Minutes of Meeting

Working Group C37.012 Application of Capacitive Current Switching for AC HV CB>1000 V

Table 1
Recirculation Comments and Dispositions

Comment ID: 293398 Page 35, Subclause 6.4.2.3, Line 1227

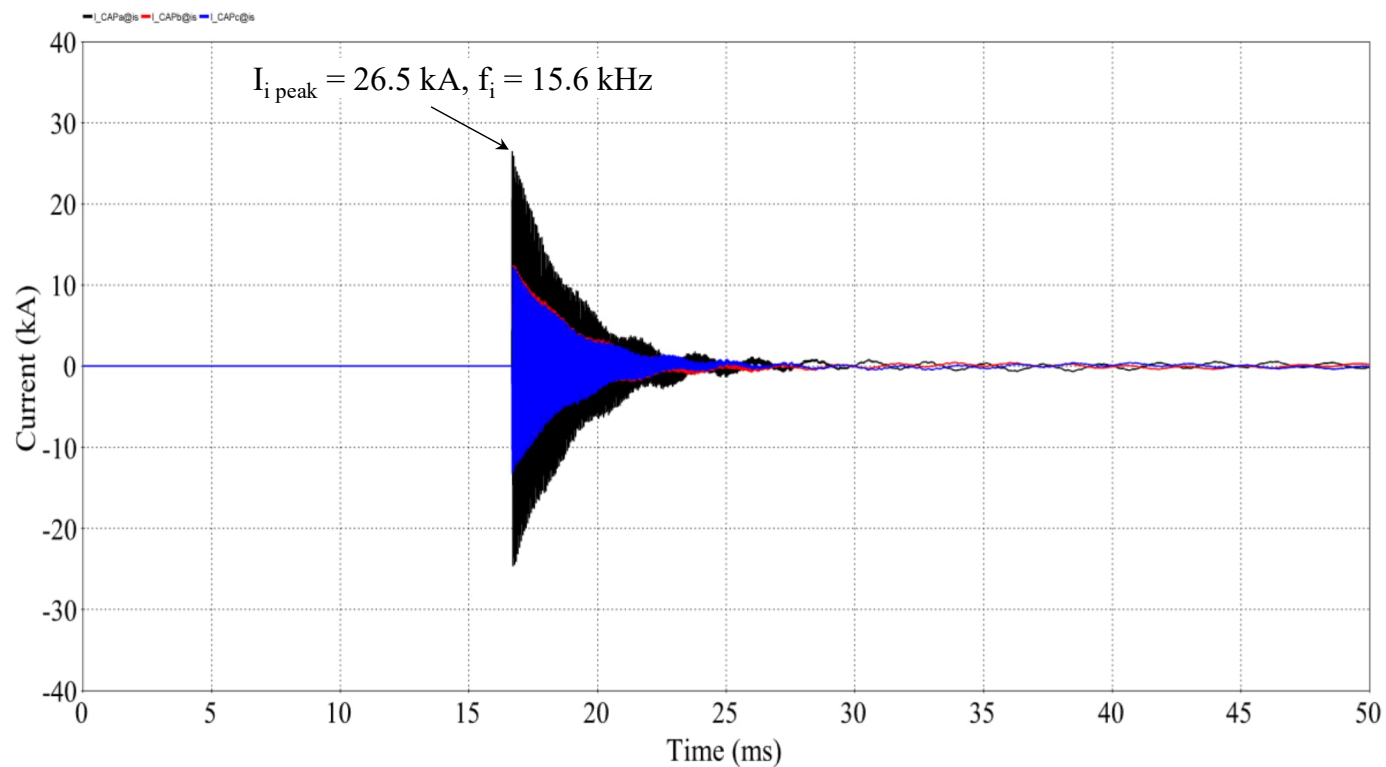
Color graphs are difficult to incorporate into a standard and should only be used when essential. Since there is no legend for the various colors, can they be eliminated?

Remove blue and red colors from Fig. 13 or add legend showing the parameters represented.

Technical	4	3	508	The definition of "transient overvoltage factor" is difficult to understand and should be improved.	No	The transient overvoltage factor is defined as the ratio of the peak transient voltage appearing during opening between a circuit breaker disconnected terminal and the neutral of the disconnected capacitance to the phase to neutral crest voltage prior to opening.	REJECTED	The proposed change does not add sufficient improvement to the existing definition.
Editorial	3	3	373	According to the IEEE Style manual the defined term should not be in the definition.	No	Delete the introductory words, "Current chopping is" (I think the editors can do this as it does not introduce a change in meaning)	REVISED	Fixed all similar instances in the definitions clause.
Editorial	35	6.4.2.3	1227	Color graphs are difficult to incorporate into a standard and should only be used when essential. Since there is no legend for the various colors, can they be eliminated?	No	Remove blue and red colors from Fig. 13 or add legend showing the parameters represented.	REVISED	Removed blue and red colors from Figure 13.
